VALLEY WATER MANAGEMENT COMPANY

February 26, 2018

Valley Water Management Company (Valley Water) submits this letter to provide comments to Proposed Resolution R5-2017-0031 and the proposed Monitoring and Reporting Program (MRP). We believe these orders are premature at this point, because Valley Water has been working cooperatively with the Central Valley Regional Water Quality Control Board (Regional Board) and has voluntarily been monitoring for many years. Valley Water is also currently engaged with your staff and is in the process of coming to agreement on the technical basis for moving forward with a sampling plan, but we are not yet at that point. We believe that the technical basis will be enhanced once Valley Water and Regional Board Staff have agreement on underlying technical issues. Until then, this matter is premature and should not be brought to the Regional Board for a hearing until there is a firmer grounding in fact.

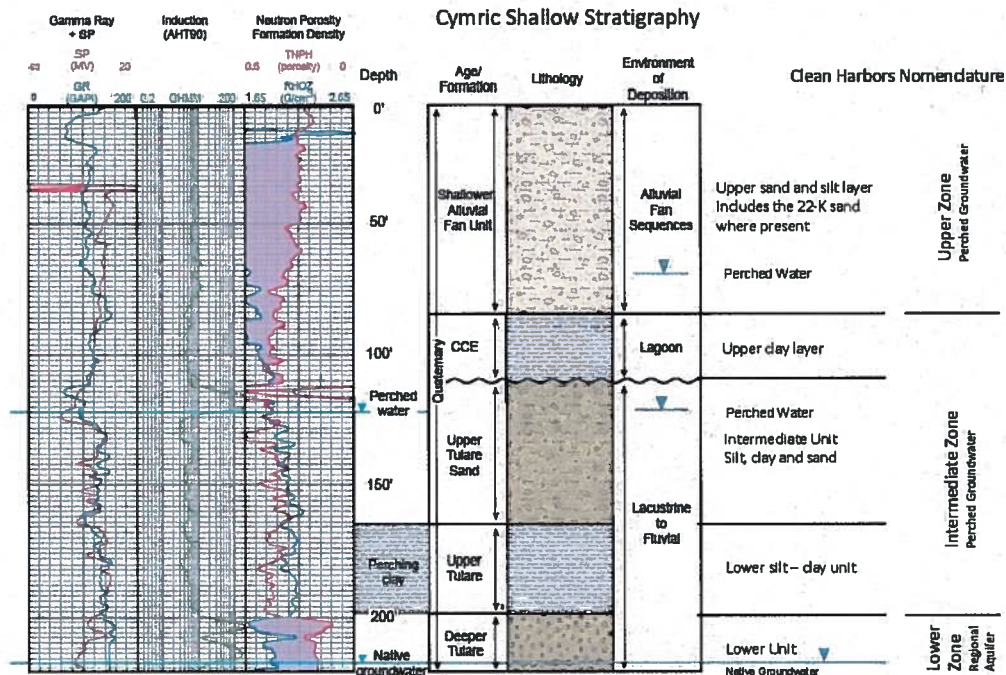
During our meeting with the Regional Board on January 10, 2018, the subject of the area stratigraphy was discussed. Valley reviewed additional data, and worked with Board staff member Doug Wachtell to address the relative stratigraphy between the Valley facility and the downgradient Clean Harbors facility at the locations shown in Figure 1.

Figure 3: Hydrogeologic Section A-A'

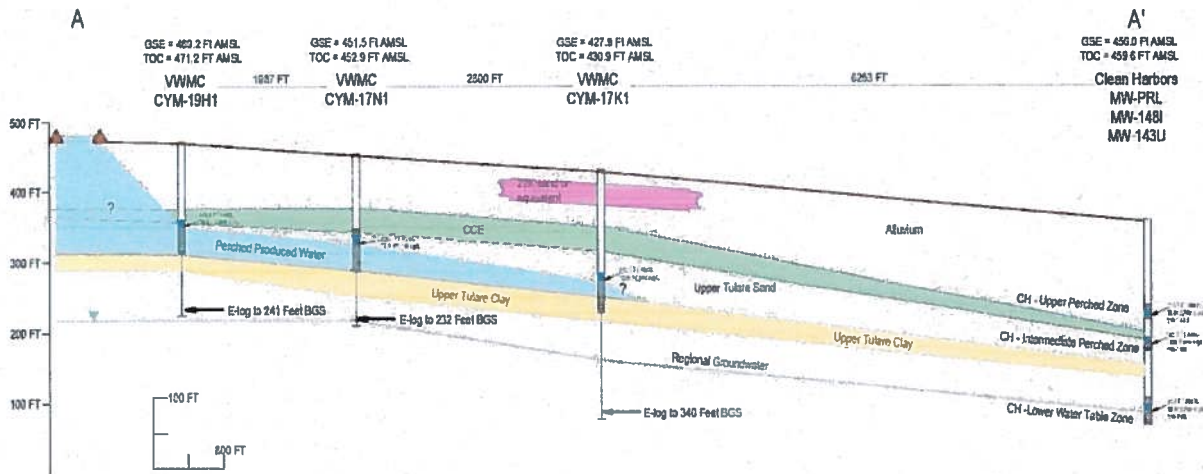
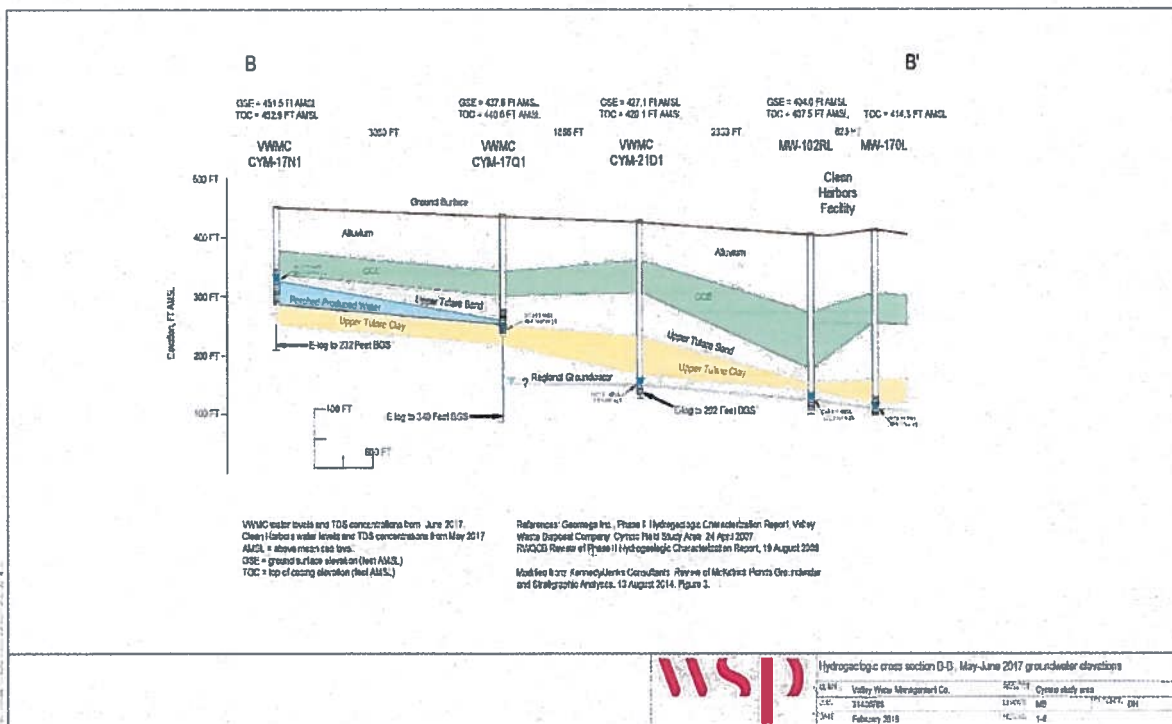
Hydrogeologic sections A-A' and B-B' in Figures 3 and 4 have been revised based on the updated stratigraphic correlation and reveal the connection between the Upper Perched Zone under the northwest portion of Clean Harbors facility and the Upper Alluvium under the McKittrick facility.

This change in stratigraphic correlation is highly significant in determining whether water in the Upper Perched Zone beneath Clean Harbors may be from McKittrick. There is no known physical mechanism whereby water from Valley, which first occurs *beneath* the CCE, could travel downgradient to Clean Harbors, and then migrate upwards *through* the CCE.

As can be seen in Figure 5, the perched water beneath Clean Harbors is in the area closest to the irrigated lands. The water found in the Upper Perched Zone beneath Clean Harbors cannot be from the McKittrick facility (as described above), but does contain compounds that implicate irrigated water. The water found in the Intermediate Perched Zone beneath Clean Harbors resembles that in the Upper Perched Zone and, therefore, is most likely to be Upper Perched Zone water that has seeped through the CCE to perch above the Upper Tulare perching clay/lower silt-clay unit (Figures 2 and 3).

Figure 4: Hydrogeologic Section B-B'

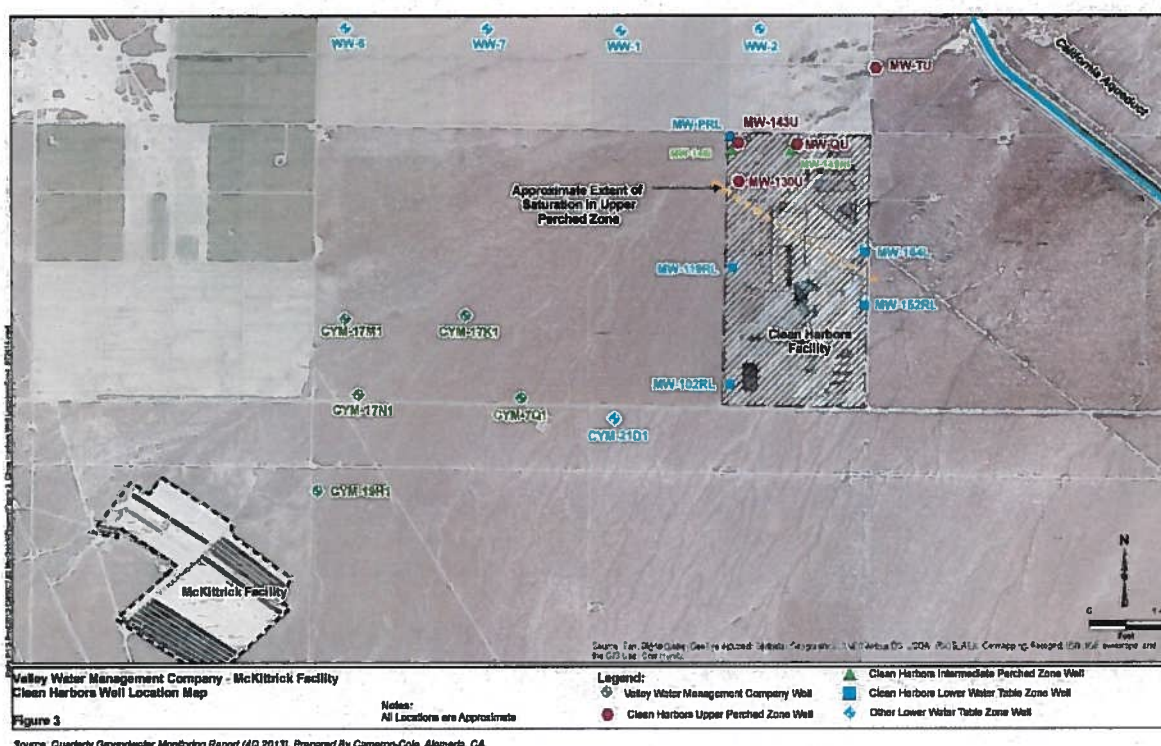
The “Upper Tulare Sand” beneath McKittrick corresponds to the “Intermediate Perched Zone” beneath Clean Harbors. Both of these units underlay the CCE, and are perched above a prominent clay layer that is laterally continuous. This unit contains water beneath both McKittrick and Clean Harbors. These units are in a lacustrine to fluvial (relatively still water) environment, compared to the Upper Alluvium/Upper Perched Zone, which is in an alluvial fan environment that may have very heterogeneous
